GE's DC Disconnect Switch Replacement Kit Provides Complete Lifecycle Solution

Product/Service Overview: Innovation and AC2000 LV AC Drive DC Disconnect

Comparison of 600A Innovation switch replacement (top) vs. obsolete switch (bottom). Please note that the installation kit and hardware are not pictured.

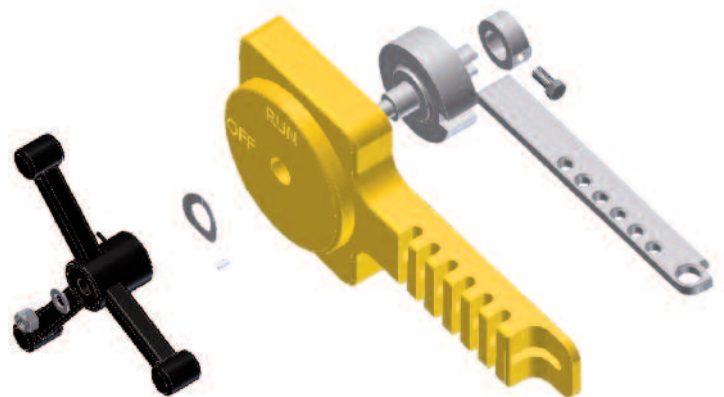
While the new DC disconnect switch offered by GE is electrically equivalent, the part is not a direct mechanical replacement. Consequently, GE replacement kits include all the necessary mounting brackets, hardware, and instructions required to execute a complete retrofit. Compared to the alternative of a complete drive system replacement, the GE solution is simple to execute, requires no additional downtime for installation, and is often the lowest cost solution.
